Access Compliance Report

Public Rights-of-Way

Intersection ID: 10034592	Main Street: PIPER_STATION_DR	Cross Street: N/A	Location: E
ADA ID: 0919FF032C53	Ramp Type: BlendTrans2	Initial Pass/Fail: Fail	Overall Compliance: No
Severity Score: 25			
Codes/Mitigation Info/Possible Solution		Field Measurements/Component Compliance

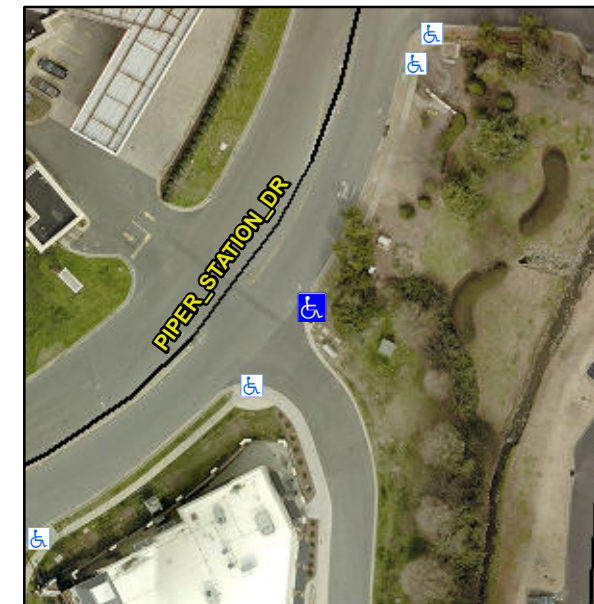
R304.5.3

Compliance	Description	Data	Compliance	Description	Data
N/A	Ramp Length (in)	43.0	Yes	BlendTrans Slope (%)	1.9
Yes	Ramp Width (in)	48.0	No	BlendTrans XSlope (%)	7.4
N/A	Flare Type LT	N/A	N/A	Flare Type RT	N/A
N/A	Flare Slope LT (%)	N/A	N/A	Flare Slope RT (%)	N/A
N/A	Flare Traversable LT?	N/A	N/A	Flare Traversable RT?	N/A
N/A	Landing Length (in)	N/A	N/A	DWS Provided?	N/A
N/A	Landing Width (in)	N/A	N/A	DWS Contrast?	N/A
N/A	Landing Slope (%)	N/A	N/A	DWS Length (in)	N/A
N/A	Landing X Slope (%)	N/A	N/A	DWS Full Width?	N/A
N/A	Landing Curb? (Y/N)	N/A	N/A	DWS Offset (in)	N/A
N/A	Shared Landing?	N/A			
N/A	Gutter Ponding?	N/A	N/A	Gutter Slope (%)	N/A
N/A	Gutter Lip Ht (in)	N/A	N/A	Gutter X Slope (%)	N/A
N/A	Painted X Walk1?	No	N/A	Painted X Walk2?	No
	X Walk 1 Direction	To NW		X Walk 2 Direction	To SW
	X Walk 1 Width (in)	N/A		X Walk 2 Width (in)	N/A
	X Walk 1 Slope (%)	3.6		X Walk 2 Slope (%)	5.4
	X Walk 1 X Slope (%)	4.9		X Walk 2 X Slope (%)	0.3

Remove & Replace Curb Ramp With Two New Directional Ramps or Equivalent.
